Access Compliance Report Public Rights-of-Way (Curb Ramps)

Main Street: N_SELLAS_RD		Cross Street: SIENNA_PKWY		Location:	SE
ADA ID: RPRK211109130159	Ramp Type:Type 1 - Perpendicular	Initial Pass/Fail: Fail	Overall Compliance: No	Severity Score:	15
Codes/Mitigation Info/Possible Solution			Field Measurements/Component Compliance

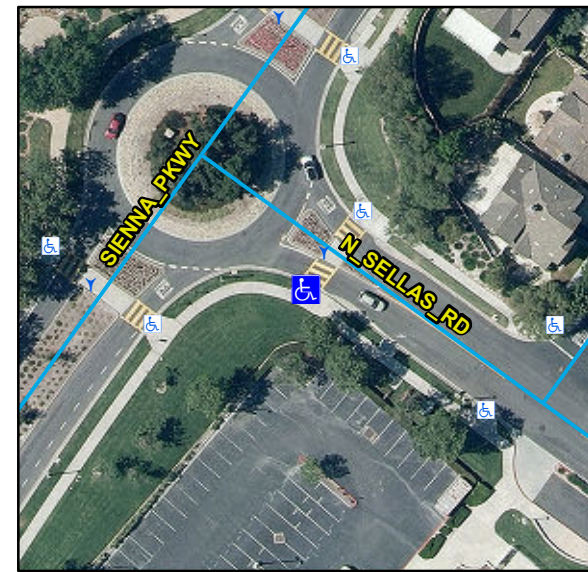
R304.2.2, R204.3, STD 1115

Remove & Replace Entire Ramp.
